SUBMITTAL SUMMARY REPORT 33488

PLAN NAME: TRACTOR SUPPLY	LOCATION: 16649 S US HWY 301 SUMMERFIELD,
APPLICATION DATE: 10/02/2025	PARCEL: 48405-001-00
DESCRIPTION:

DRIVEWAY MODIFICATION PLAN
 US-301, Summerfield, FL 34491
 PARCEL ID # 48405-001-00
 JUNE 2025

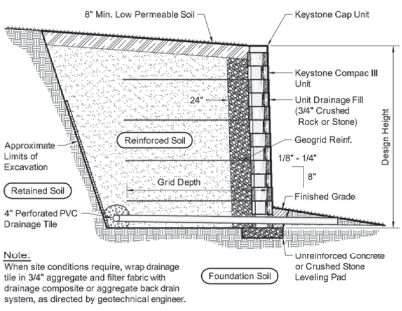
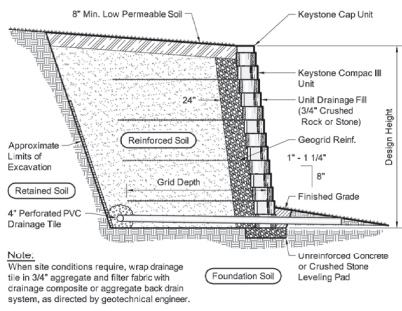
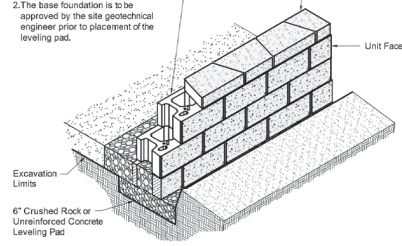
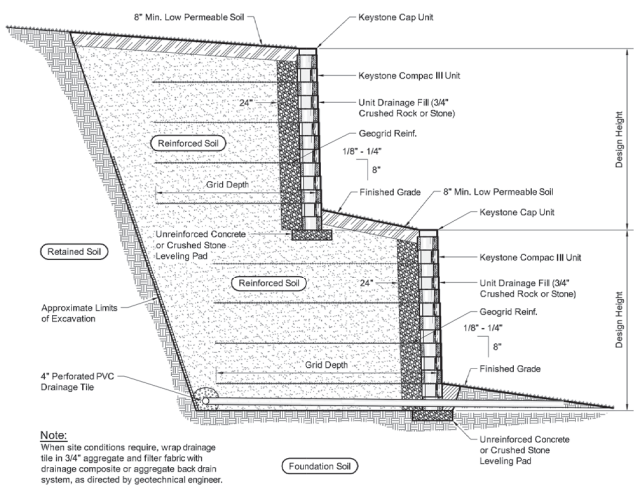
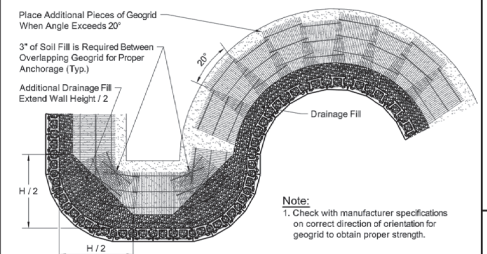
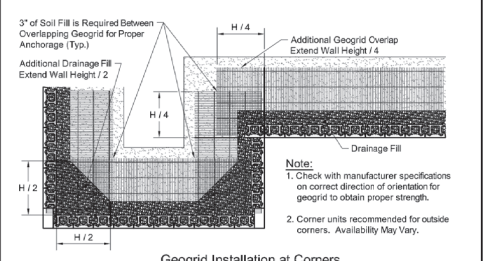
ITEM REVIEW NAME (DEPARTMENT)	ASSIGNED TO	DUE	COMPLETE	STATUS
OCE Stormwater (Permits & Plans) (Office of the County Engineer)	Kevin Vickers	12/09/2025	11/25/2025	Requires Re-submit
<i>Corrections</i>	Additional Stormwater comments (Not Resolved) - Corrective Action: (1) If you have questions or would like to discuss the stormwater review comments, please contact Kevin Vickers, PE at 352-671-8695 or kevin.vickers@marionfl.org. (2) Please submit a copy of the DRA ownership/maintenance agreement for staff review. (3) Proposed grading and drainage modifications that impact the FDOT ROW drainage systems need to be coordinated directly with FDOT. - Additional Stormwater comments			
<i>Corrections</i>	6.13.2.A.3 - Retention/Detention Design Parameters (Not Resolved) - Corrective Action: (1) Please update DRA cross sections to extend across entire DRA. Please also update the cross sections to include the maintenance berm width. (2) Please add the following note with the pond cross section: "A minimum of three feet of unconsolidated soil material shall be provided between the surface of any limestone bedrock and the bottom and sides of any stormwater facility." (3) Add coordinates or dimensions to the major pond components (changes in alignment, corners, etc) for constructability. - 6.13.2.A.3 - Retention/Detention Design Parameters: Show location and design parameters for all retention/detention areas including: 1. Dimensions or coordinates for constructability. 2. Cross sections along the width and length of each pond, showing the design high water elevation, estimated seasonal high water elevation, pond top elevation, pond bottom elevation, side slope steepness, maintenance berm width, sod stabilization of the pond side slopes, and appropriate vegetative cover on the pond bottom. 3. Soil boring location with labels.
